From: Stephen milliner [REDACTED]
Sent: 28 October 2018 16:46
To: Laura Gibbons
Cc: Juan Baeza; Planning
Subject: 60 Vermont Drive - Application EP/131/18/DOC

H.M. LAND REGISTRY		TITLE NUMBER WSX 20 148 7	
ORDNANCE SURVEY PLAN REFERENCE	TQ 0701	SECTION F	Scale 1/1250
COUNTY WEST SUSSEX	DISTRICT ARUN	© Crown copyright 1977

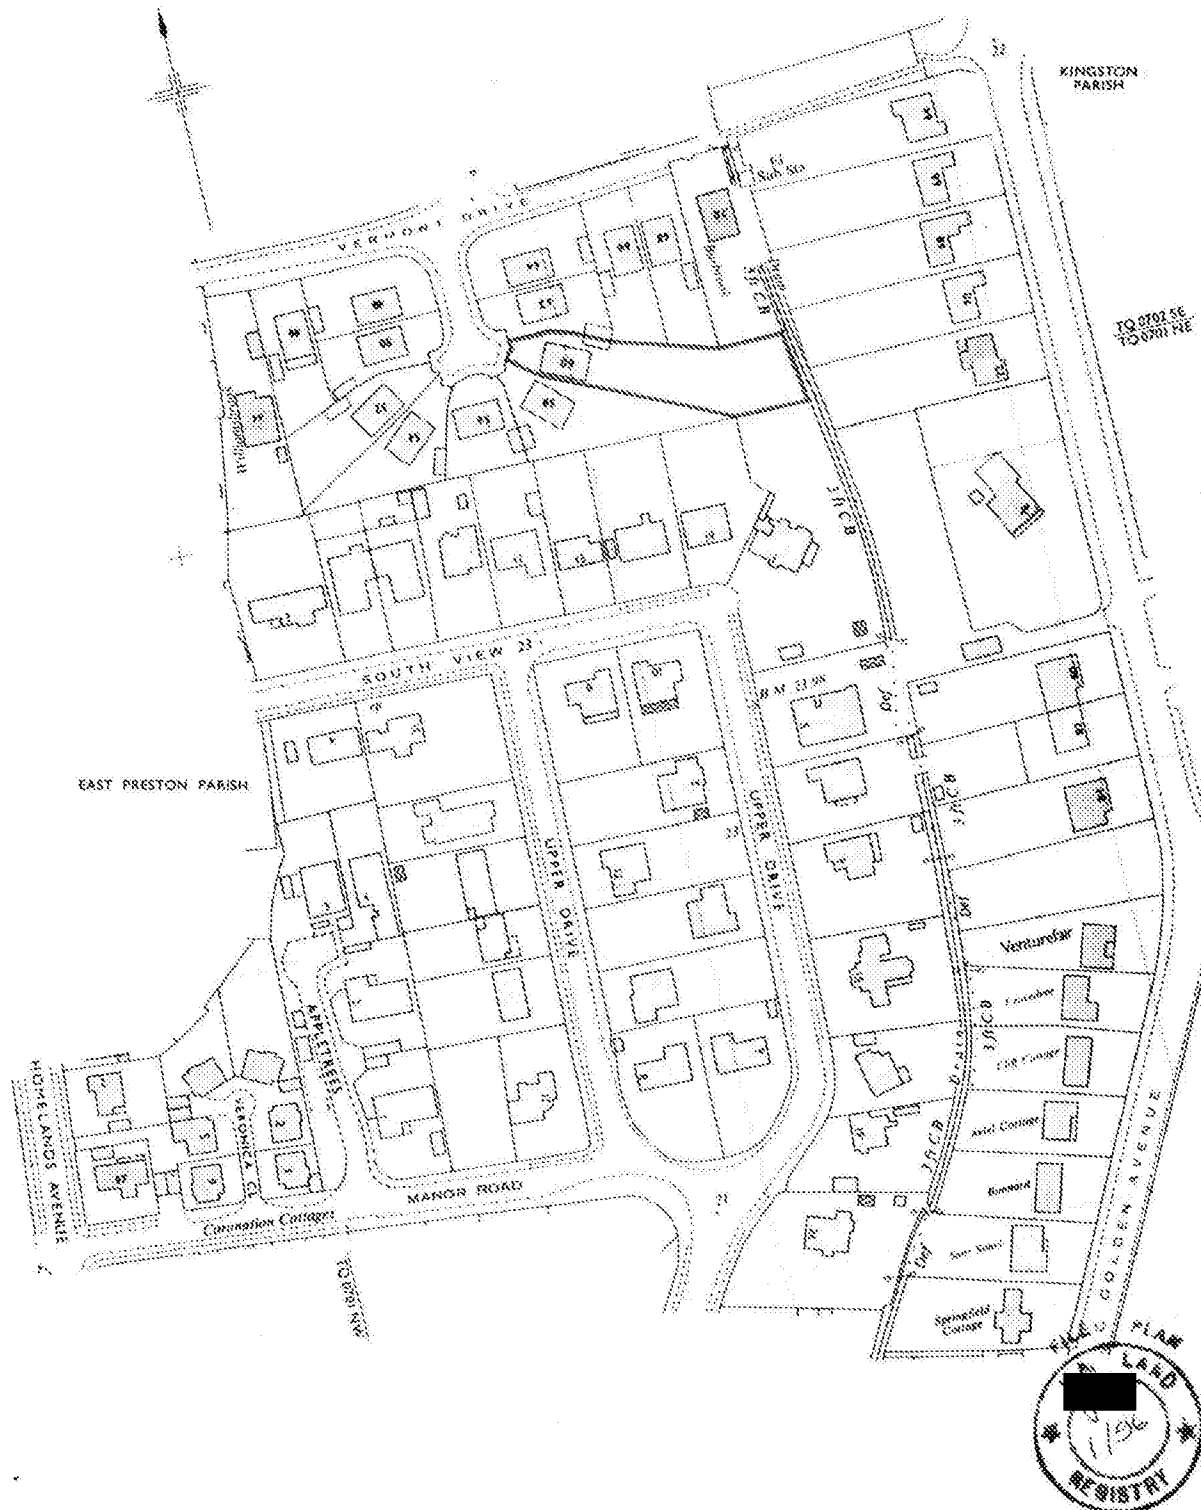
I see you have some doubt about the watercourse so to give you some comfort I enclose a copy of the H.M. Land Registry details which clearly shows the drain.
